December 28th
IEPA letter to
Lindberg
Addresses RAP
for HTB

Re: 0311860011 - Cook County
Lindberg Heat Treating
ILD005071808
Log No. C-544-M-20
Date Received: August 17, 2000
SRP/Technical

This letter is in response to the August 16, 2000 Remedial Action Plan for the Heat Treating Building at the above-referenced facility that was prepared by Mr. Paul Steinburg, P.E., LSP of Mabbett & Associates, Inc. (M&A) on behalf of Lindberg Heat Treating Company Inc. (LHT). Remedial activities for contamination in the Heat Treating Building (HTB) and Gantry Building Salt Building (GB/SB) at the subject facility are being carried out under Illinois EPA's Site Remediation Program. A site layout map showing the location of these buildings within the subject facility is attached. The Illinois EPA's May 15, 2000 (Log No. 544-M-19) letter required that a Remedial Action Plan (RAP) be submitted for the HTB and GB/SB as the next step to address soil and groundwater contamination present at these units. The RAP for the GB/SB was received by Illinois EPA on November 8, 2000 and will be responded to at a later date.

Site Layout Map
 Lindberg Heat Treating

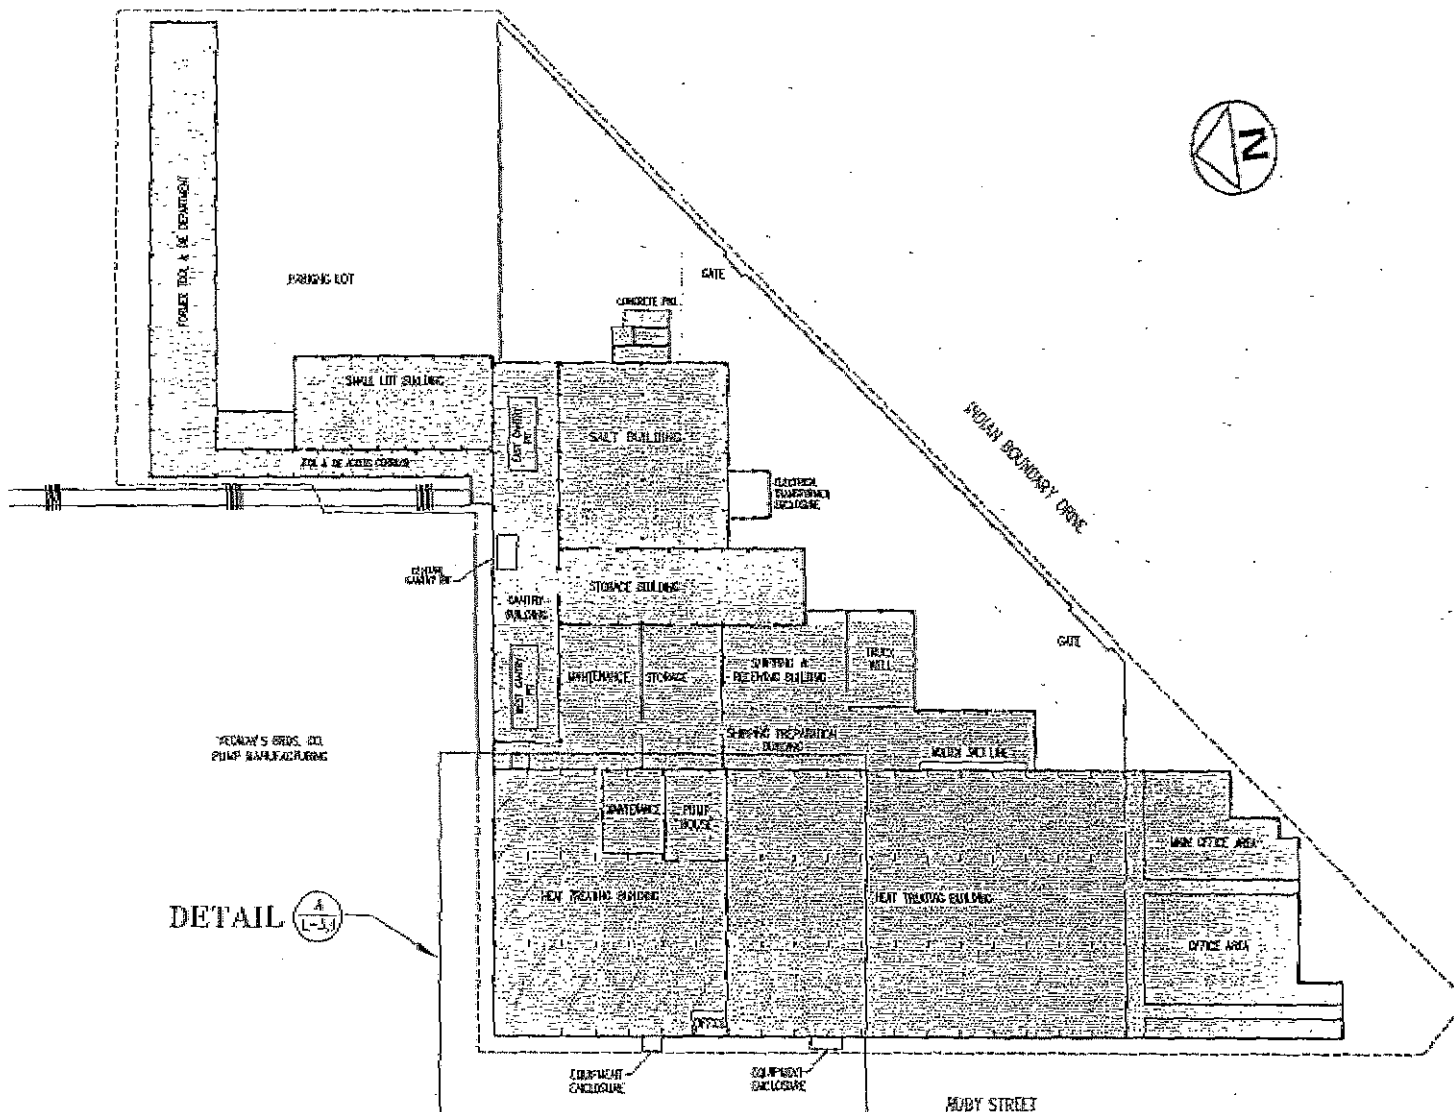
The subject RAP for the HTB was submitted to address two areas of soil and groundwater contamination in the HTB in the vicinity of: (1) wells M&A 104, 110, 111 and 113 where dense non-aqueous phase liquids (DNAPL), primarily trichloroethylene are present; and (2) wells M&A-2, M&A 310 and M&A 114 where light non-aqueous phase liquid (LNAPL), primarily petroleum and non-chlorinated VOCs are present. A drawing showing the location of these areas within the HTB is attached.

Layout of Heat Treating Building
Lindberg Heat Treating

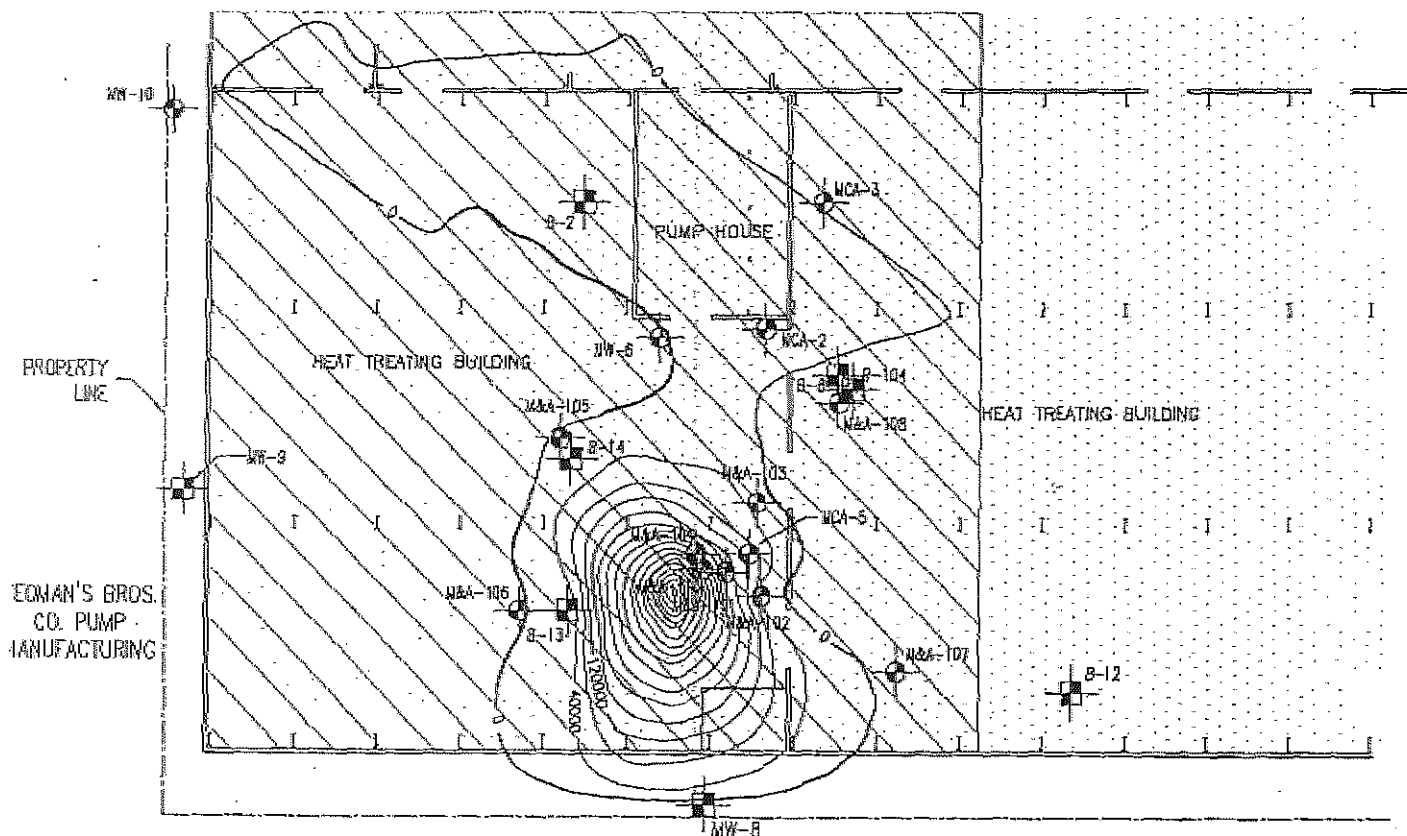
4. Page 7 of the RAP for the HTB refers to Drawing L-4 as being the area subject to deed restriction and requiring maintenance of an engineered barrier. The drawing does not indicate that an engineered barrier will be maintained to the 0 contour line east of the HTB (towards Ruby Street) as required by the Illinois EPA's May 15, 2000 approval letter. LHT must resubmit a map indicating that an engineered barrier will be maintained up to the 0 contour line as an addendum to the RAP for the HTB.
